SUBJECT: CATAWBA NUCLEAR STATION, UNITS 1 AND 2 - STAFF ASSESSMENT OF INFORMATION PROVIDED PURSUANT TO TITLE 10 OF THE *CODE OF FEDERAL REGULATIONS* PART 50, SECTION 50.54(f), SEISMIC HAZARD REEVALUATIONS RELATING TO RECOMMENDATION 2.1 OF THE NEAR-TERM TASK FORCE REVIEW OF INSIGHTS FROM THE FUKUSHIMA DAI-ICHI ACCIDENT (TAC NOS. MF3965 AND MF3966)

STAFF ASSESSMENT BY THE OFFICE OF NUCLEAR REACTOR REGULATION

RELATED TO SEISMIC HAZARD AND SCREENING REPORT

CATAWBA NUCLEAR STATION, UNIT S. 1 AND 2

Figure 3.3-1 Plot of Staff's and Licensee's Base Case Shear-Wave Velocity Profiles for the Catawba site

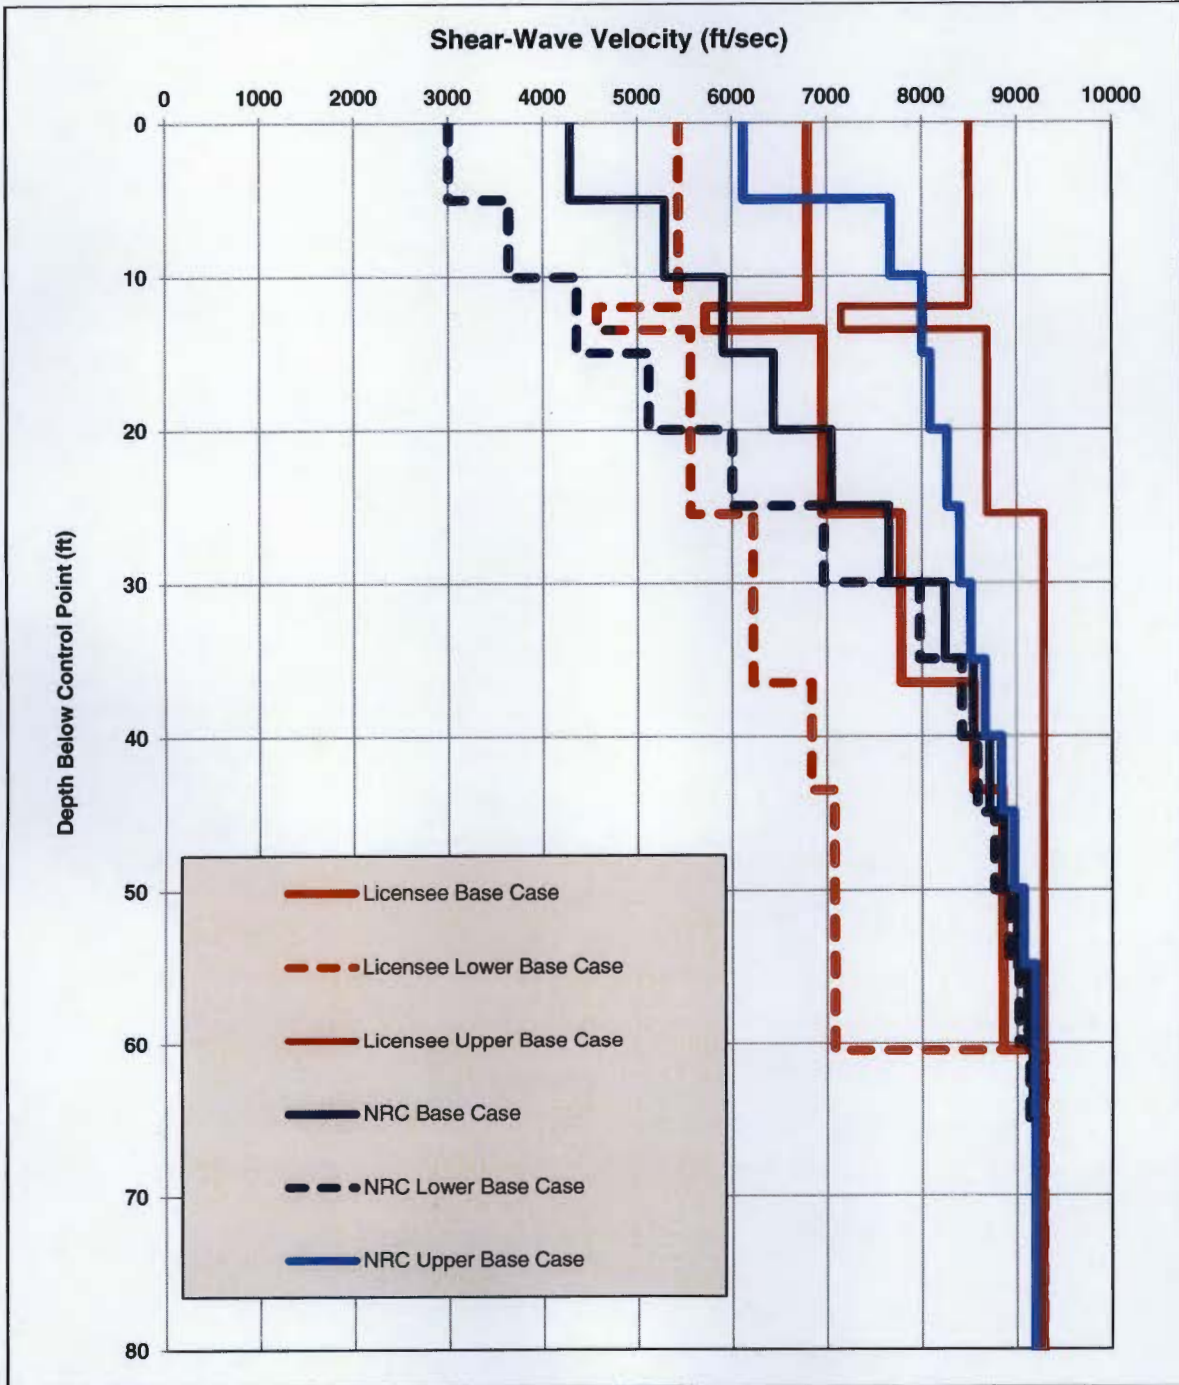
To characterize the subsurface geology, the licensee developed three site base case profiles. The middle, or best estimate, profile was developed using shear-wave velocity data from downhole measurements at the site, which extended to a depth of 103 ft (31.4 m). The licensee extrapolated shear-wave velocities below this depth. Although Section 3.1 of the SHSR states that the SSE corresponds to foundations on closely jointed rock and slightly weathered rock, the licensee also included 12 ft [3.7 m] of fill concrete at the top of the site response profile. The licensee estimated the shear-wave velocity of concrete based on unit weight, unconfined compressive strength, and assumed Poisson's ratio provided in the SHSR. Upper and lower

base case profiles were developed by the licensee using a natural log deviation of 0.2. Figure 3.3-1 of this assessment shows the licensee's three shear-wave velocity base case profiles. As the SPID recommends that a site's control point elevation should be at the top of competent rock, the staff asked the licensee to justify including the fill concrete in its site response profile. In a letter dated January 8, 2015, 2015 (Henderson, 2015), the licensee responded to the staff's request for additional information by stating that the concrete fill was considered an extension of the underlying rock and was used to restore the foundation elevation. The licensee further stated that in at a few locations across the site the top of continuous rock is below the design bottom of the substructure mat of significant structures such as the Reactor Building. As such, at these locations, fill concrete was placed to extend the top of continuous rock up to the foundation grade level. As described below, the staff evaluated the licensee's inclusion of about 12 ft [3.7 m] of concrete fill in its site profile by performing a confirmatory site response analysis. The staff's results show that the licensee's inclusion of the fill concrete had a negligible impact on the resulting hazard curves and GMRS.

To capture the uncertainty in the site subsurface geology, the staff developed three base case shear-wave velocity profiles. The upper and lower base case shear-wave velocity profiles are based on the downhole measurements obtained from Borings A-61 and A-63, which are presented in Figures 2-98 and 2-99, respectively, of the Catawba, Units 1 and 2 UFSAR (Duke Energy Carolinas, 2012). The middle or best estimate base case profile represents the geometric mean of the shear wave velocities for the upper and lower base case profiles. The staff's base case profiles are similar to the licensee's profiles above the depth of 25 ft [7.6 m]. Below this depth the shear wave velocities for the licensee's lower base case profile are lower than the staff's velocities for its lower base case profile. In addition to the differences in the lower base case profile, the licensee's and staff's profiles also differ for the upper layer because the staff did not include the 12 ft [3.7 m] of fill concrete in its site response profile. As described below, these differences between the staff's and licensee's profiles did not have a significant impact on the final hazard curves or GMRS for the site. Figure 3.3-1 of this assessment shows the staff velocity profile compared to the base case profiles developed by the licensee.

Figure 3.3- 2 Plot Comparing the Staff's and the License's Median Amplification Functions and Uncertainties for two input loading levels for the Catawba site

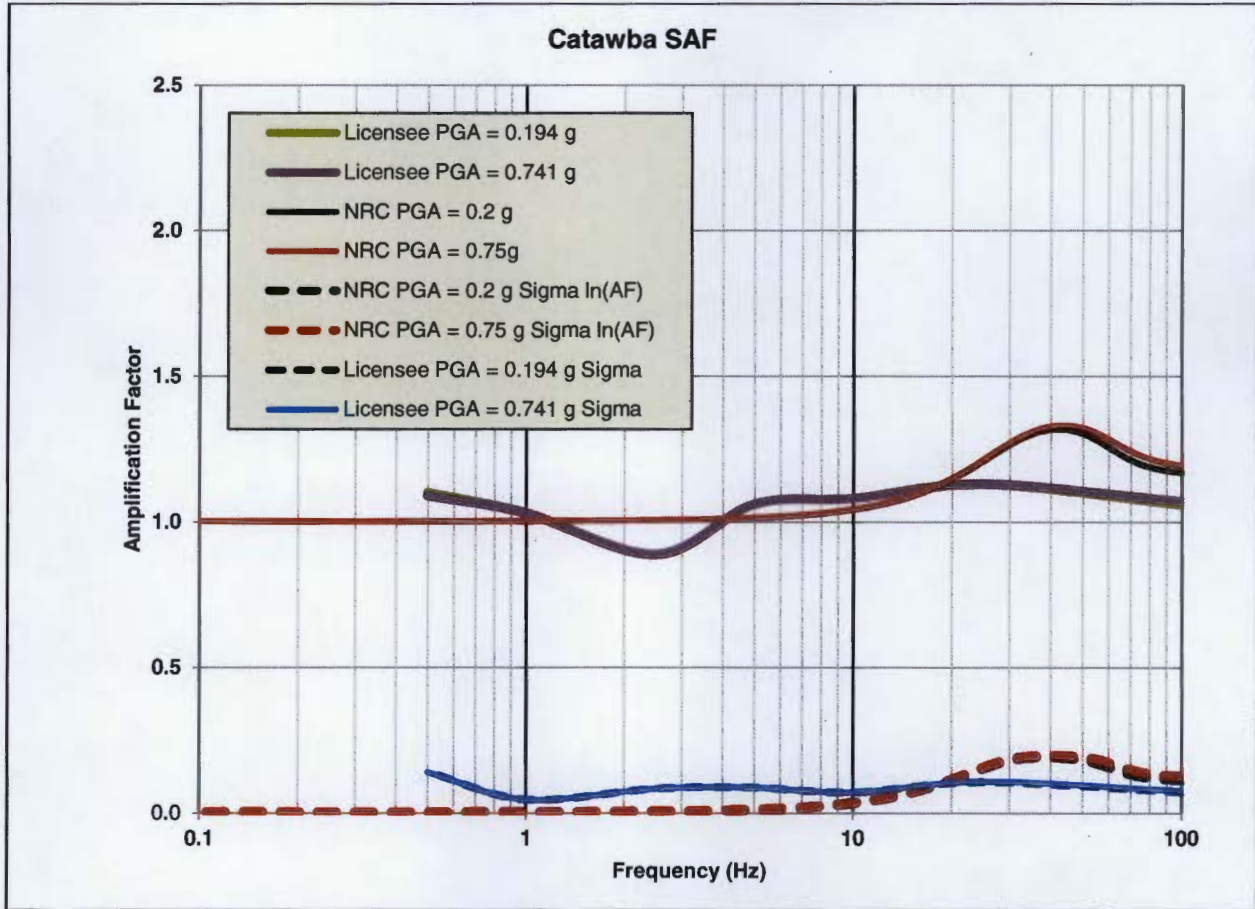
Figure 3.3-2 of this assessment shows a comparison of the staff's and licensee's median site amplification functions and uncertainties (± 1 standard deviation) for two of the eleven input loading levels. Due to the use of low damping values and modeling of the rock behavior as linear, the staff's confirmatory amplification factors are essentially one for the frequency range below approximately 10 Hz. Amplification functions calculated by the licensee are also fairly close to

one, varying between 0.8 to 1.3 for frequencies above 20 Hz. In addition, the staff's calculated amplification factor uncertainties are very similar to those of the licensee's.

Figure 3.3-3 Plot Comparing the Staff's and the Licensee's Mean Control Point Hazard Curves at a Variety of Frequencies for the Catawba site

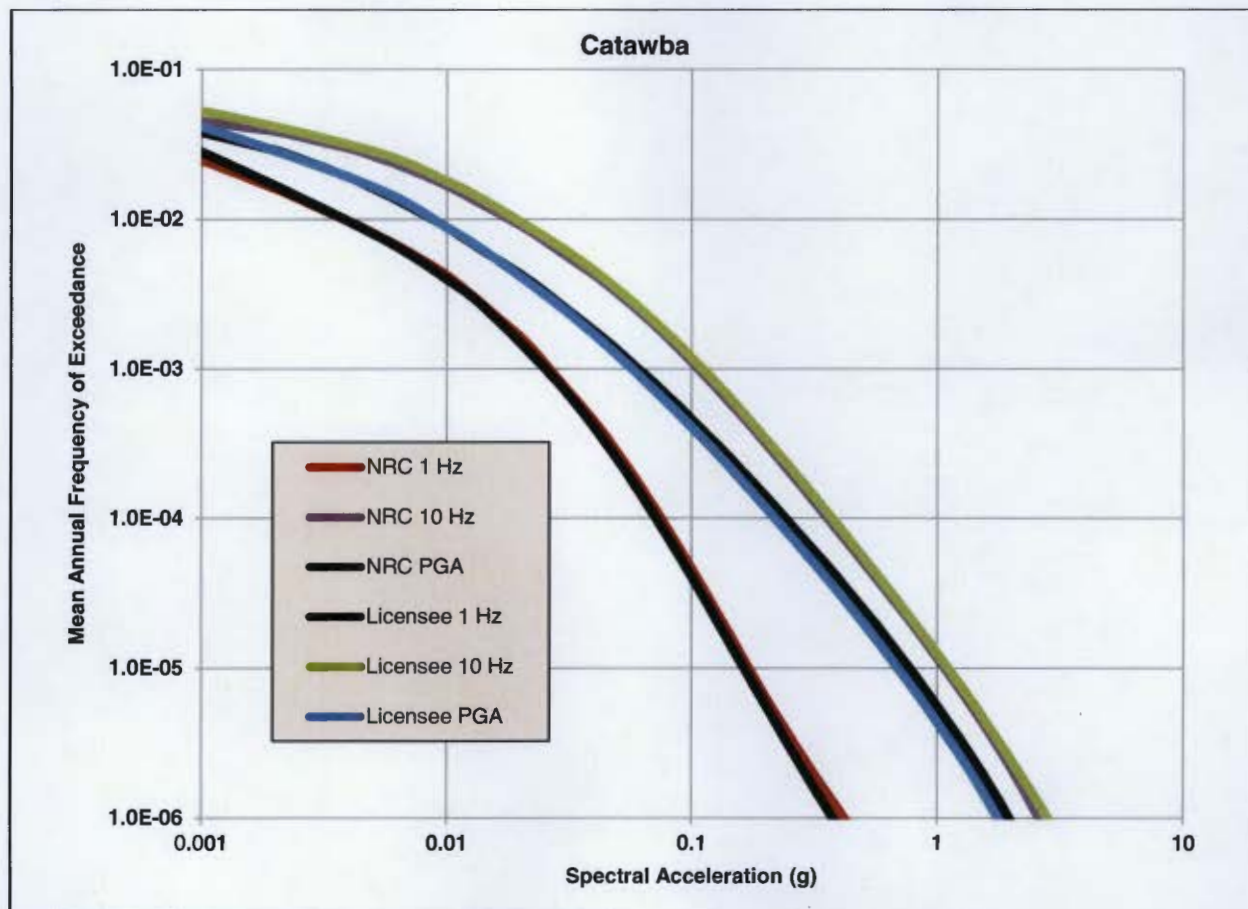
Overall, the licensee's approach to modeling the subsurface rock properties and their uncertainty results in amplification factors that vary more than those developed by the staff. However, as shown in Figure 3.3-3 of this assessment, these small differences in the site response analysis do not have a large impact on the control point seismic hazard curves or the resulting GMRS, as discussed below. Appendix B of the SPID provides guidance for performing site response analyses, including capturing the uncertainty for sites with less subsurface data; however, the guidance is neither entirely prescriptive nor comprehensive. As such, alternative approaches in performing site response analyses, including the modeling of uncertainty, are acceptable for this application.

Figure 3.4-1 Comparison of the Staff's GMRS with Licensee's GMRS and the SSE for the Catawba site

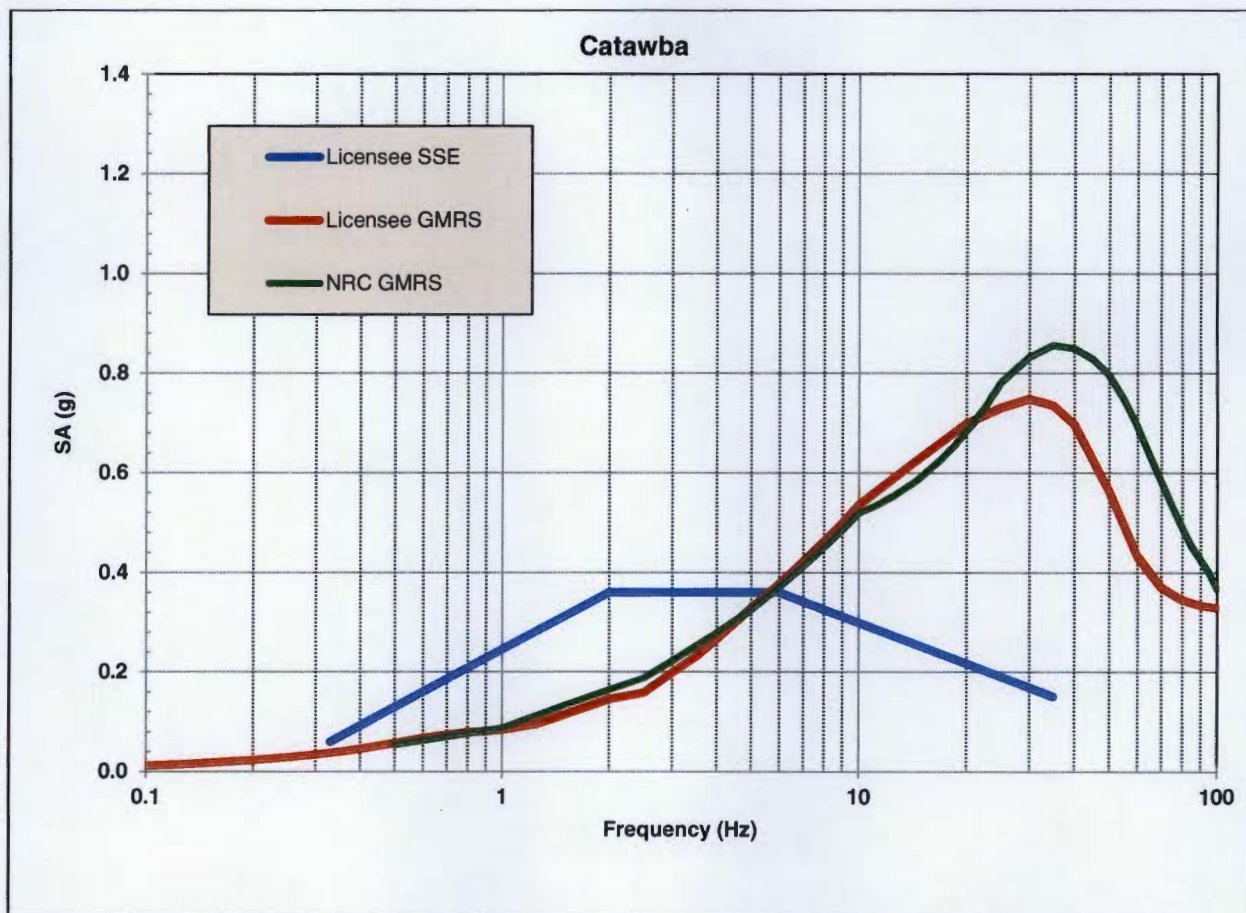
The staff independently calculated the 10^{-4} and 10^{-5} UHRS using the results of its confirmatory PSHA and site response analyses, as described in Sections 3.2 and 3.3 of this staff assessment, respectively. Figure 3.4-1 of this assessment shows a comparison of the GMRS determined by the licensee to that determined by the staff.

As shown in Figure 3.4-1, the licensee's GMRS is similar to the staff's confirmatory GMRS. However, NRC staff's confirmatory GMRS is higher than the licensee's at frequencies above 20 Hz. As described above in Section 3.3, the staff concludes that these differences over the higher frequency range are primarily due to the differences in the site response analyses performed by the licensee and staff. The staff concludes that these differences are acceptable for the response to the 50.54(f) letter because the licensee followed the guidance provided in the SPID with respect to both the PSHA and site response analysis for the Catawba site.

The staff confirms that the licensee used the present-day guidance and methodology outlined in RG 1.208 and the SPID to calculate the horizontal GMRS, as requested in the 50.54(f) letter. As such, the staff concludes that the GMRS determined by the licensee adequately characterizes the reevaluated hazard for the Catawba site. Therefore, this GMRS is suitable for use in subsequent evaluations and confirmations, as needed, for the response to the 50.54(f) letter. The staff performed both a PSHA and site response confirmatory analysis and achieved results consistent with the licensee's horizontal GMRS.
